Combined Victorian Society Testimony for June 11, 2024: Proposed Willoughby-Hart Historic District, Brooklyn (LP-2683); 402 West 20th Street (LPC-24-08677); Soldiers and Sailors Monument, Riverside (LPC-24-10137)

LPC-24-10137 -- Soldiers and Sailors Monument, Riverside Park - Soldiers' and Sailors' Monument - Scenic Landmark and Individual Landmark, Manhattan

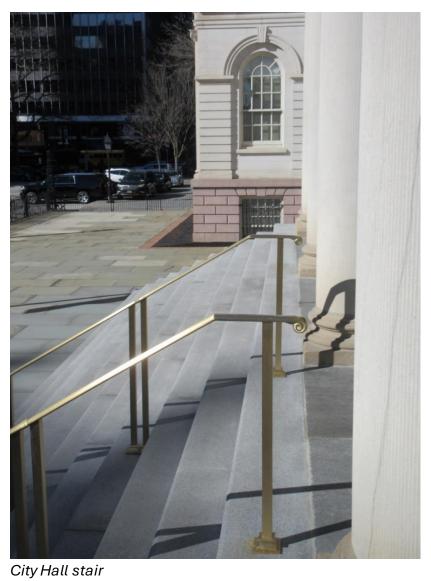
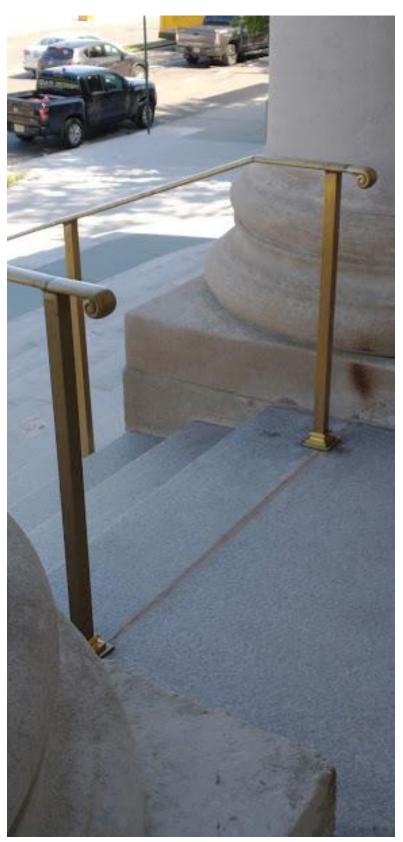
There are many new and replacement handrails proposed for the stairs and a short section of ramp. These are proposed to be of extremely simple, square-sectioned form. This is a mistake. Instead of helping them disappear, this design will stand out as a modern

intrusion within the Beaux Arts splendor of the monument and the picturesque landscape of the park. We recommend simple changes, such as adding volutes to the ends of the rails and softer, historically elegant shapes to the rails and posts. This will allow the new railings to blend more comfortably with their historic surroundings. Some examples are provided in our written testimony.

Some recent, classically inspired handrails that we think would be a better fit at the monument are shown below:

Favorable report 8-0, with the following recommendations: ensure that railing design is minimal and doesn't detract, explore ways to retain visibility of wall's base at west side, explore pavement setting details for durability; one commissioner suggested relocating new stair to the north.
